DUKE POWER COMPANY

Re: Catawba Nuclear Station
Docket Nos. 50-413 and 50-414

My letter of January 20, 1982 transmitted a list of Action Items which was compiled during a December 15-18, 1981 meeting with the Structural Engineering Branch. Responses to these Action Items are attached except for Items 27, 31, and 32 which will be provided by May 7, 1982.

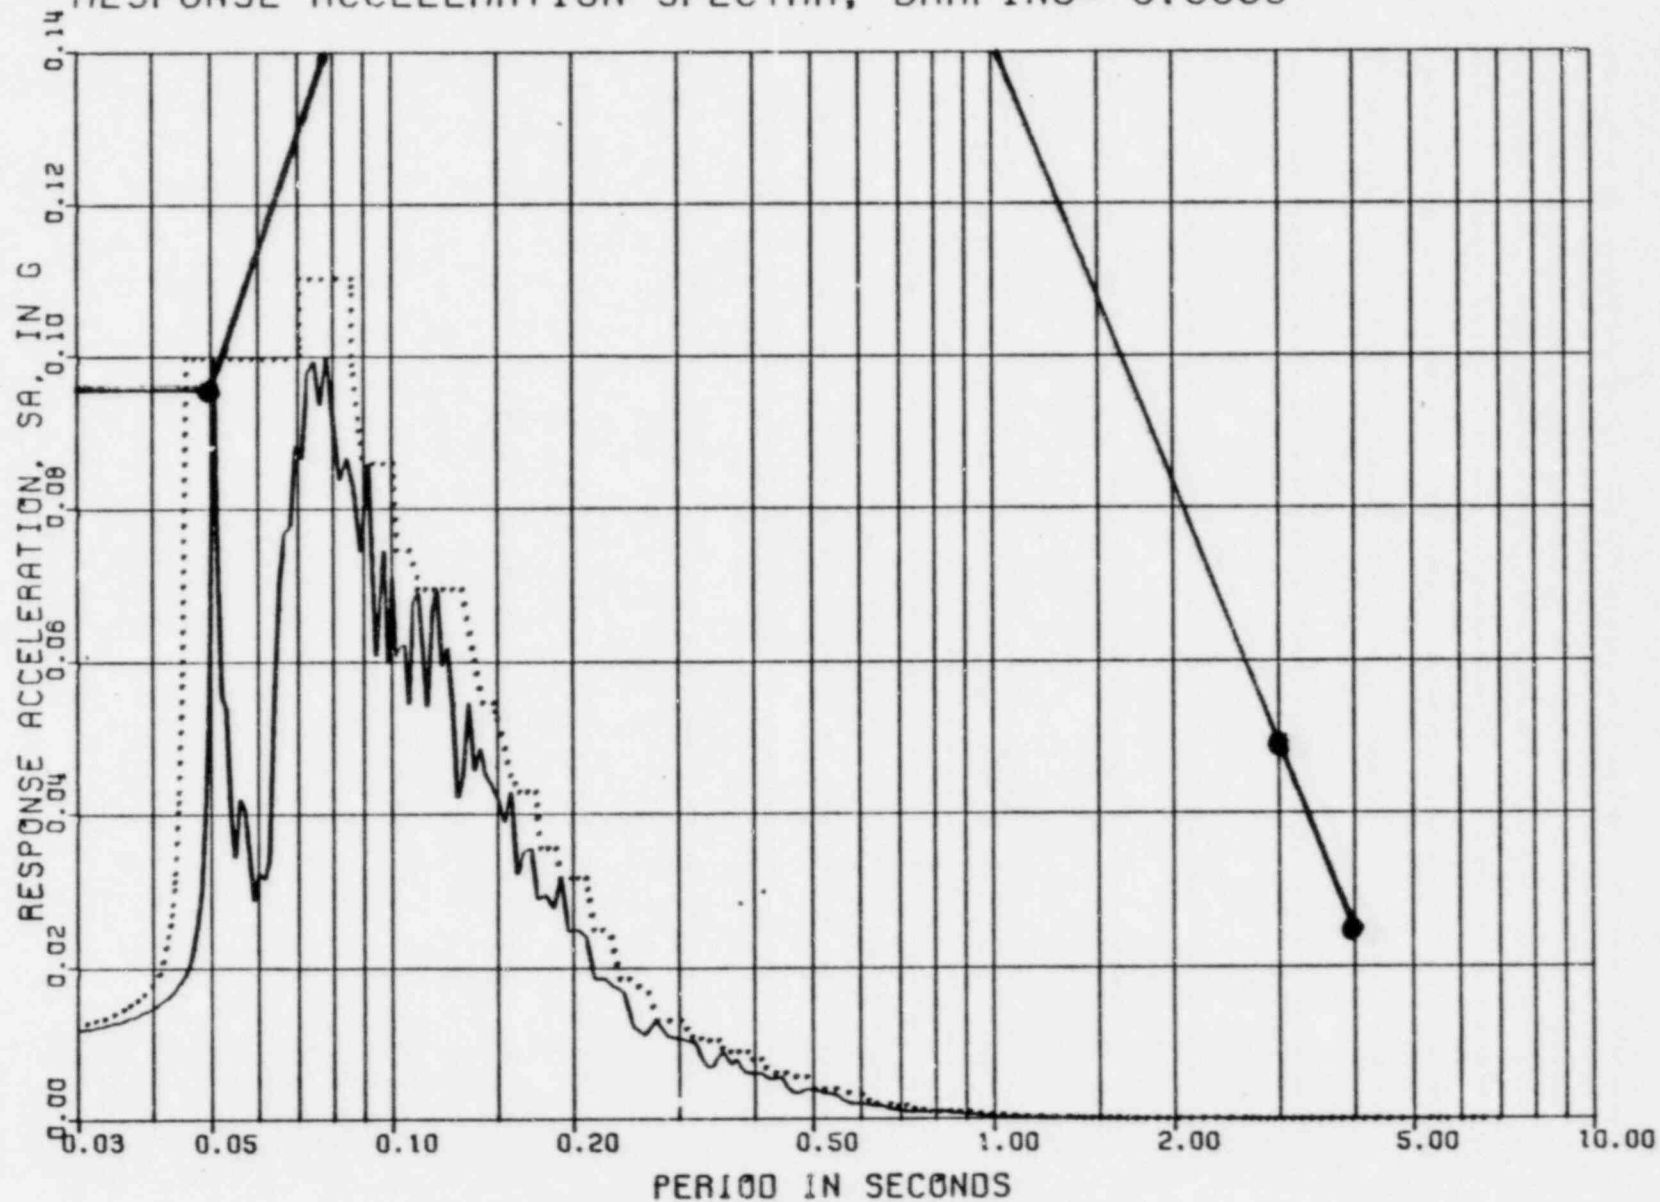
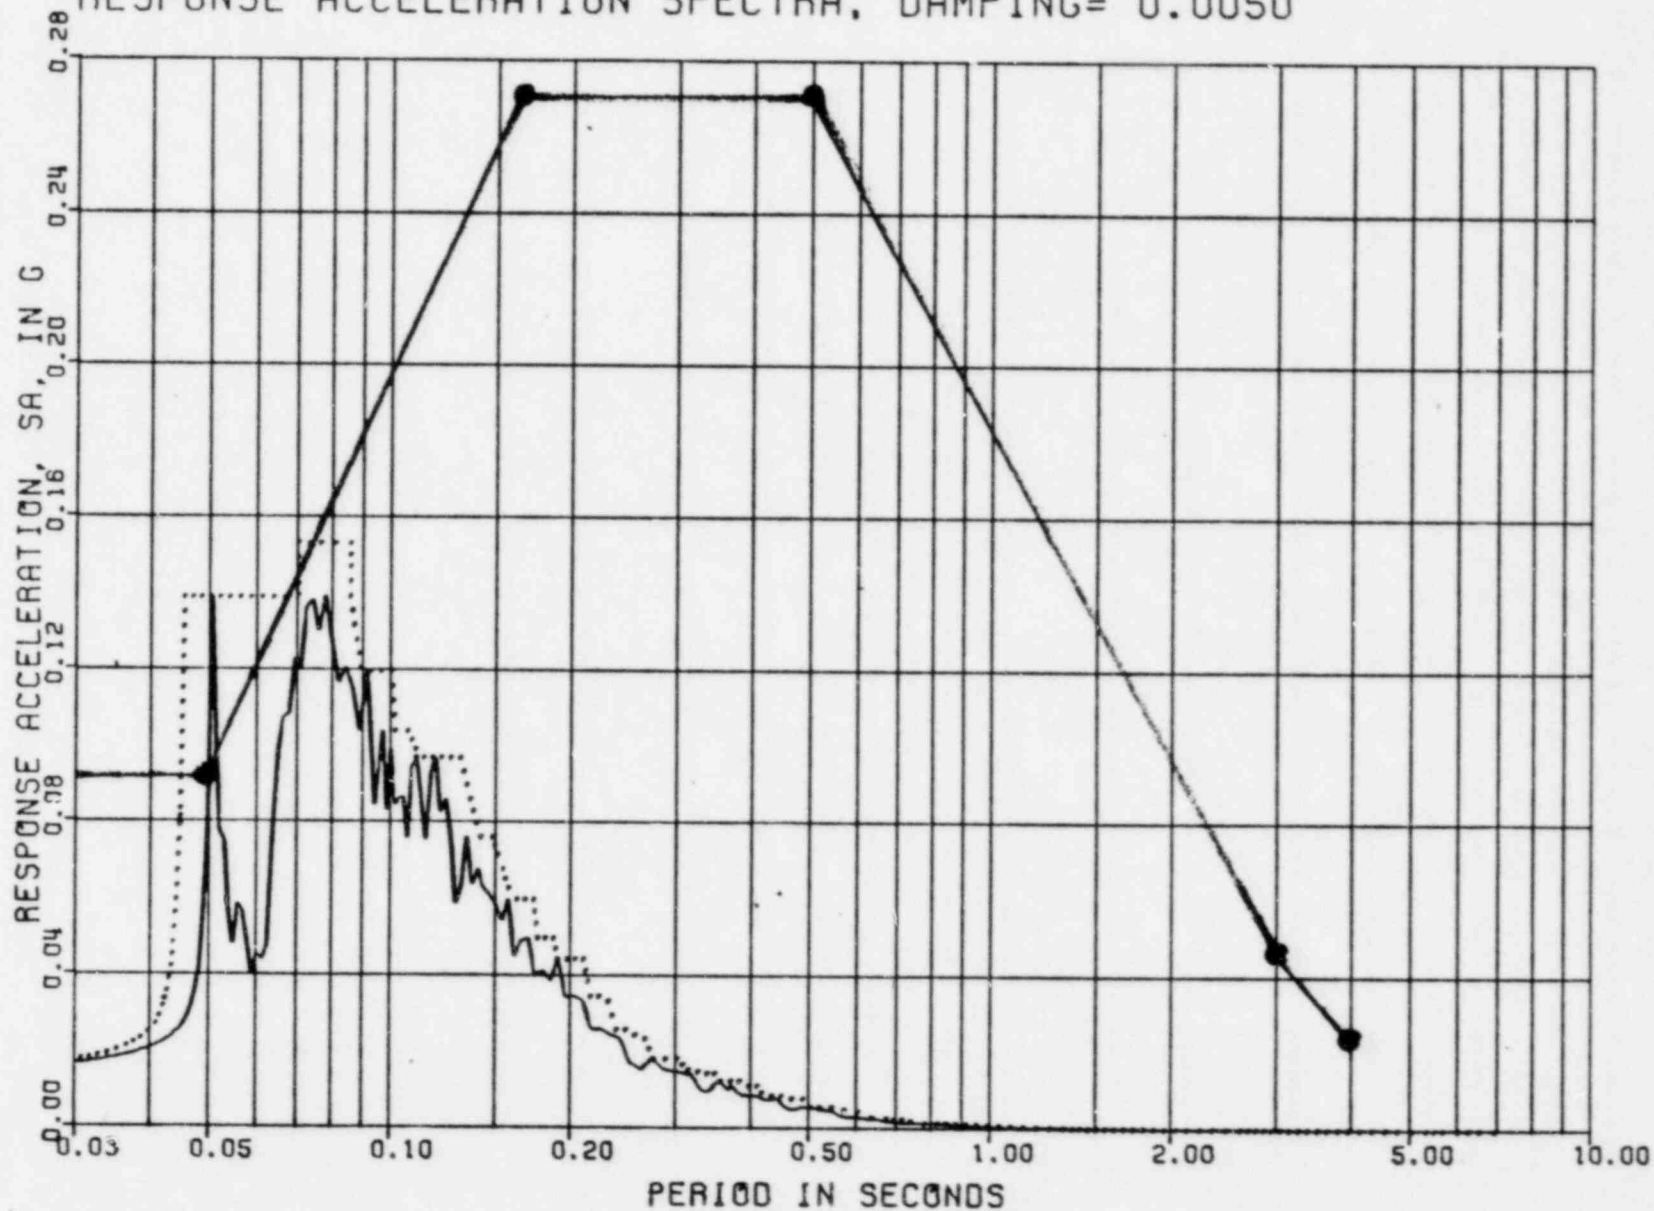
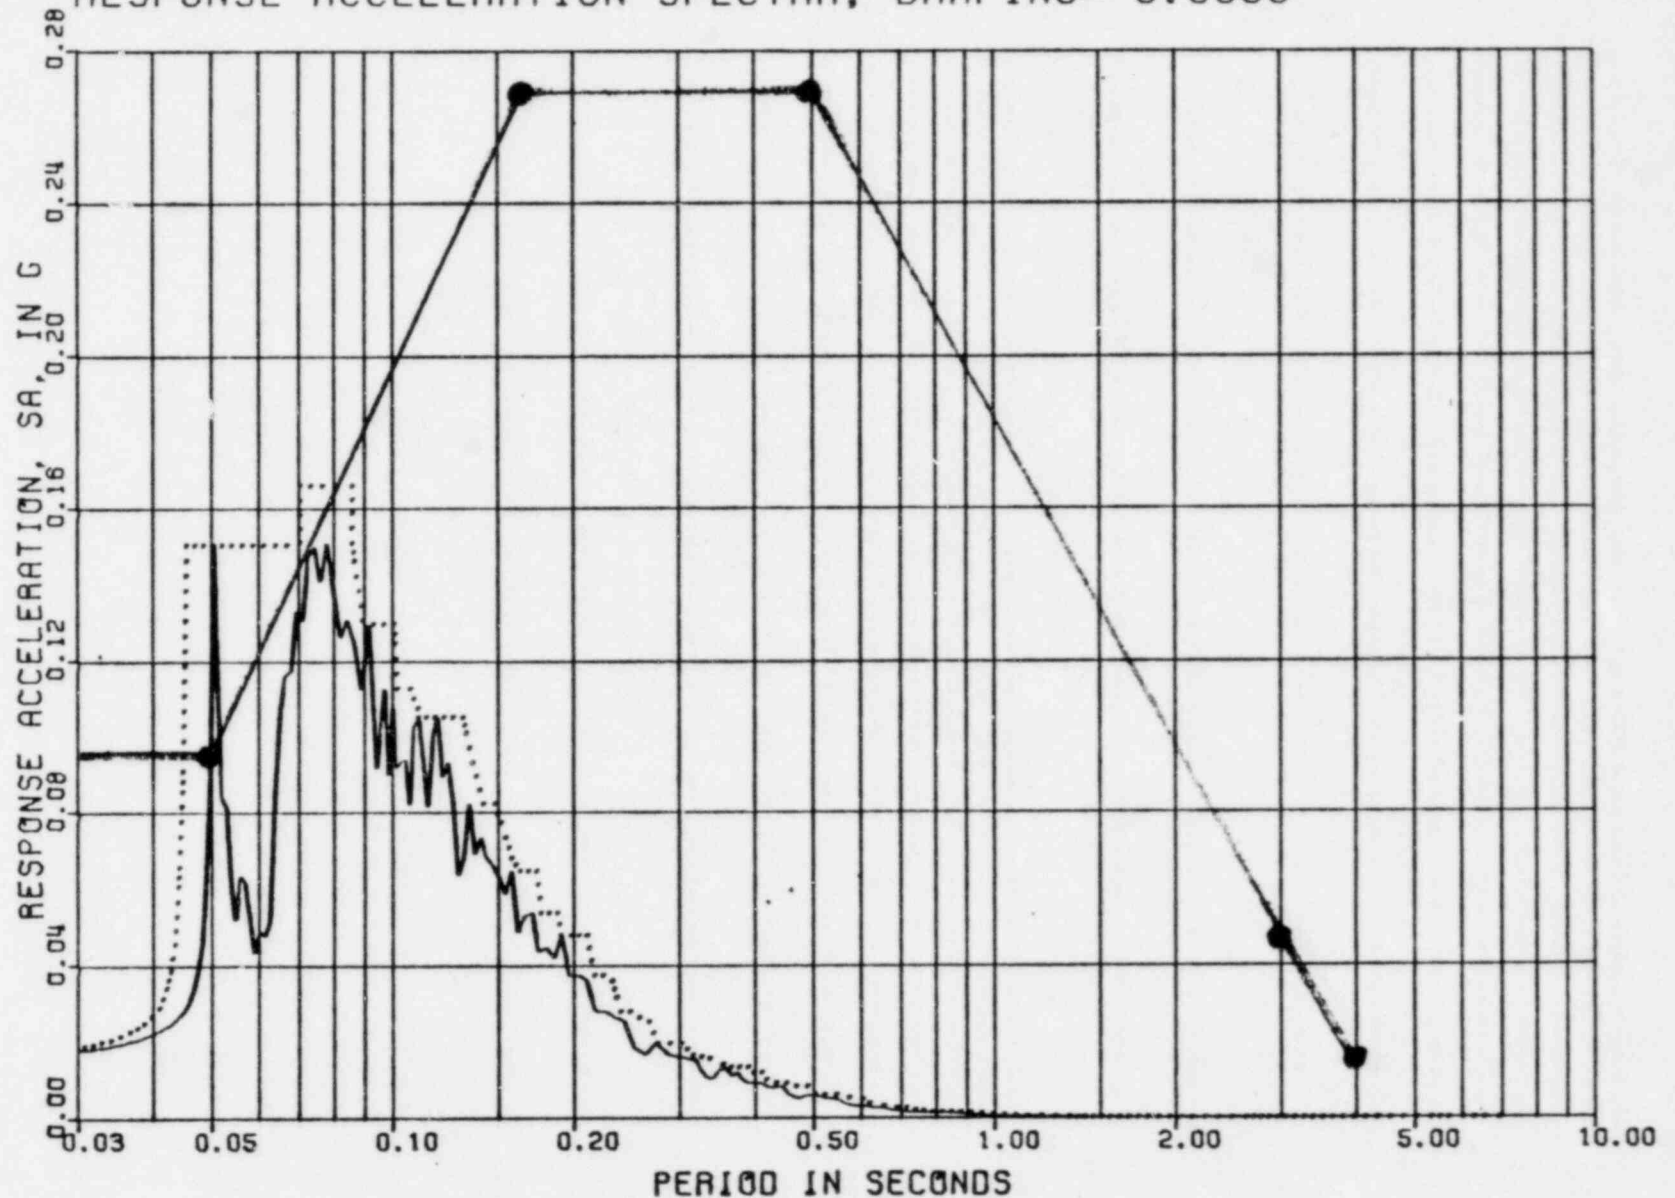
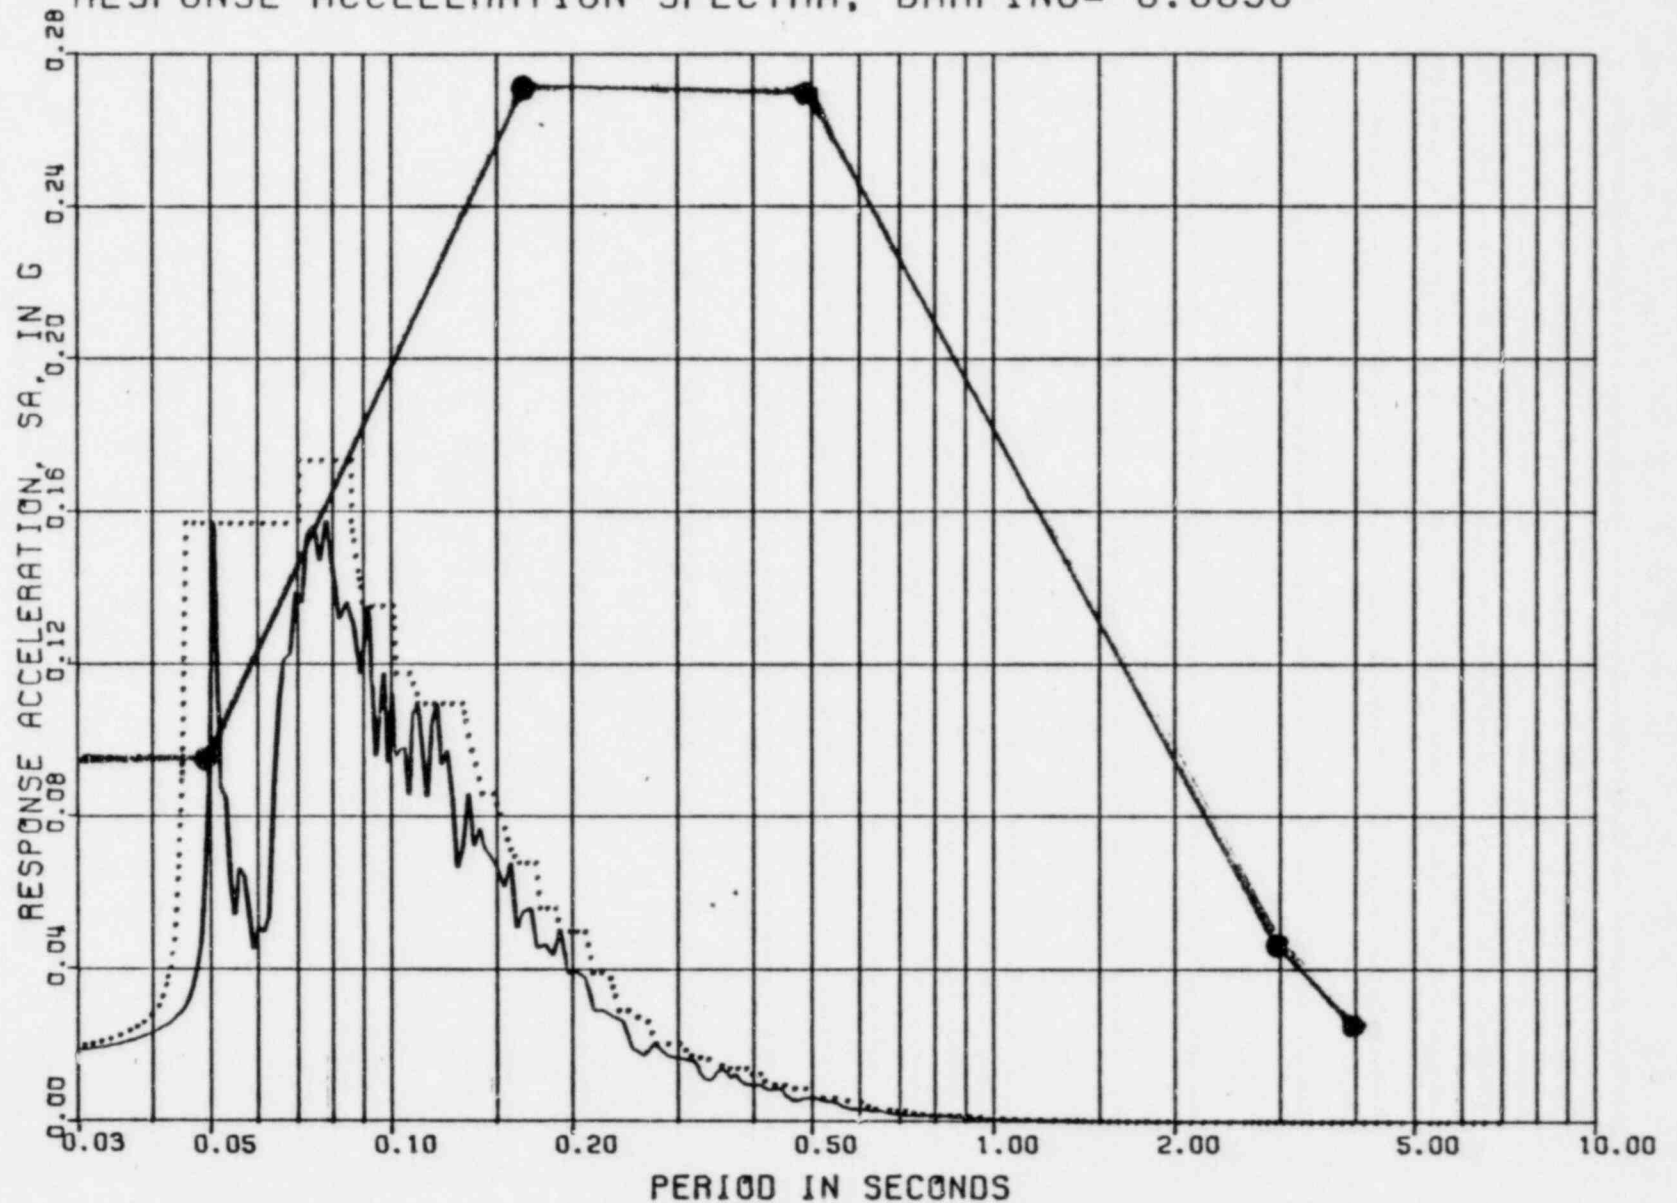
10. Provide justification demonstrating negligible amplification assumed in vertical seismic analysis (interior structure, auxiliary building, and steel containment).

For a damping ratio of 0.005, several spectra (Figures 10-6, -10, -14, and -18) have isolated peaks in the vicinity of period $T = .05$ sec which exceed the envelope of $2/3$ of ground response. Inspection of FSAR Section 3.7.1.3 reveals that this damping ratio does not apply to the containment vessel or its attachments and therefore this phenomenon has no impact upon design of Category I structures, systems or components.

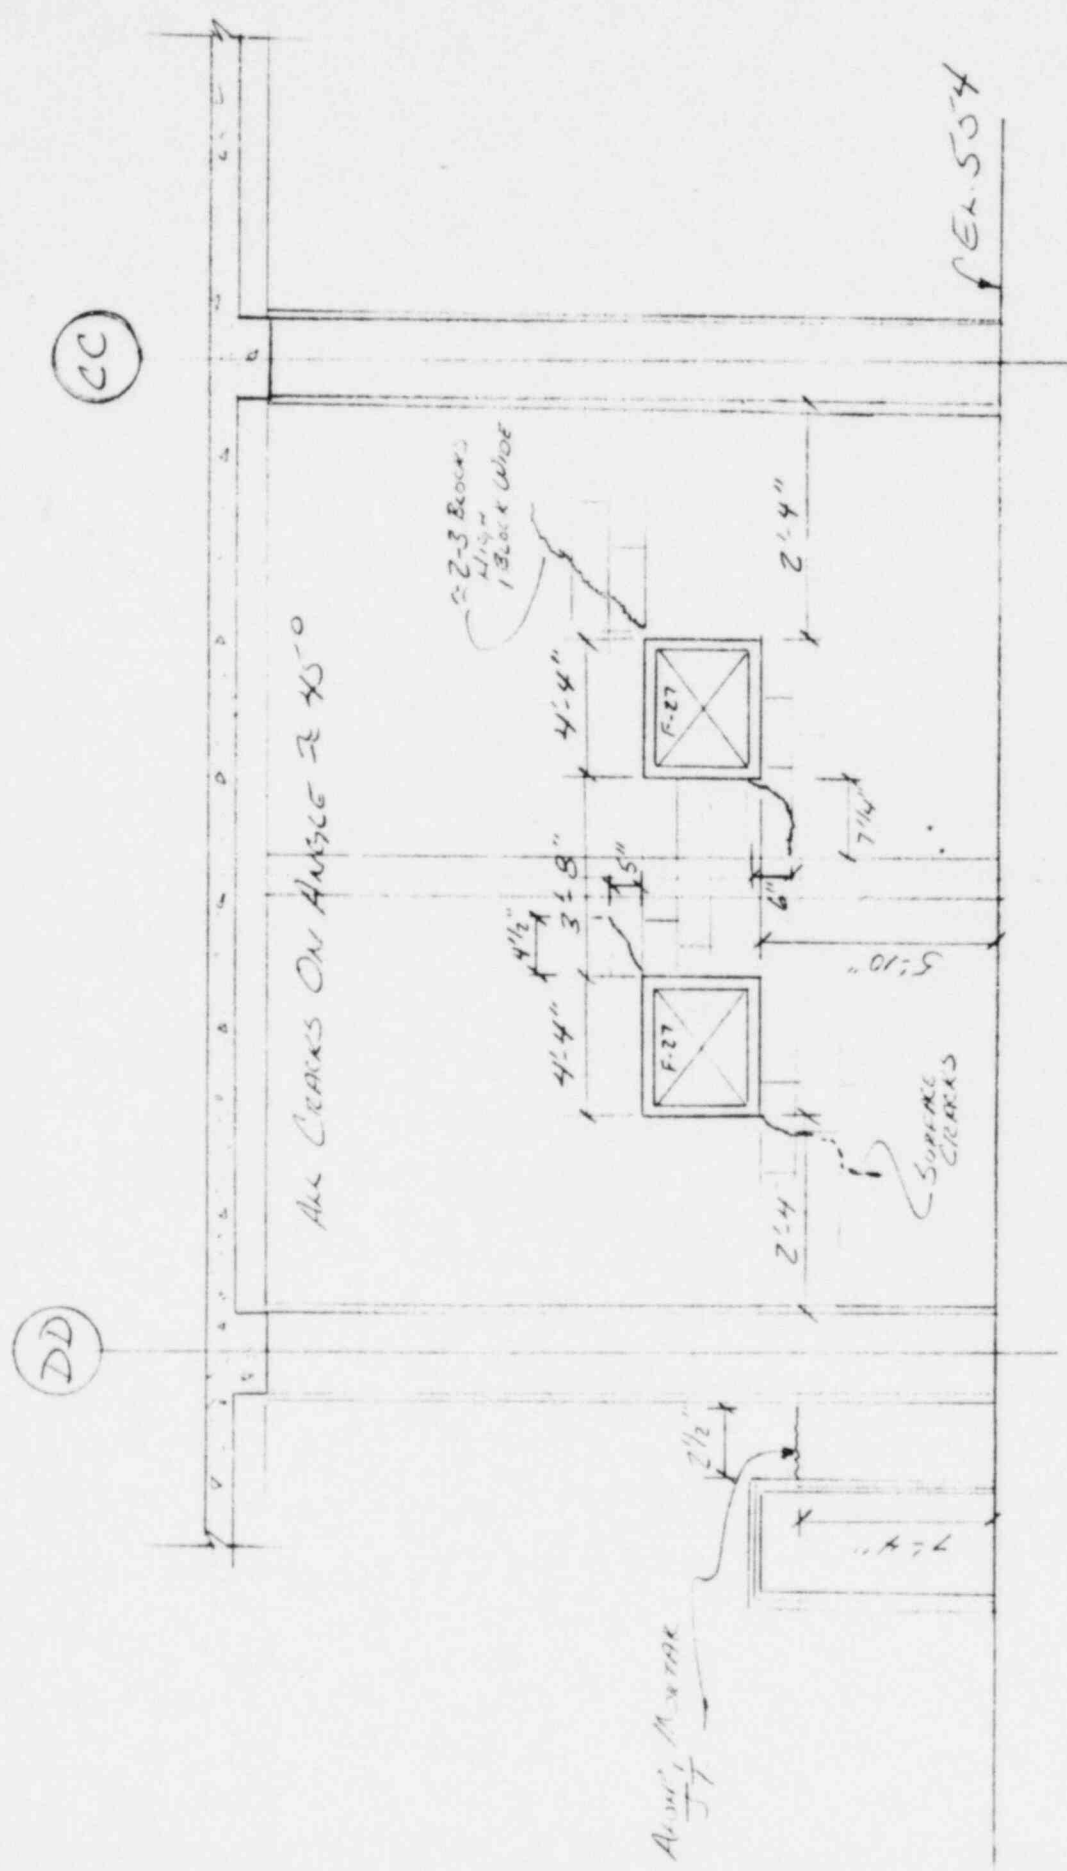
41. Regarding the two cracks identified in masonry wall during the site visit on December 15, 1981, Duke will provide: A) location and description of the cracks; B) probable cause of the cracks; C) Duke's proposal for correcting the cracks.

Attached is a figure detailing the locations of cracks identified during the December 15, 1981 site visit. An inspection of other block walls in this area did not reveal any other cracks.
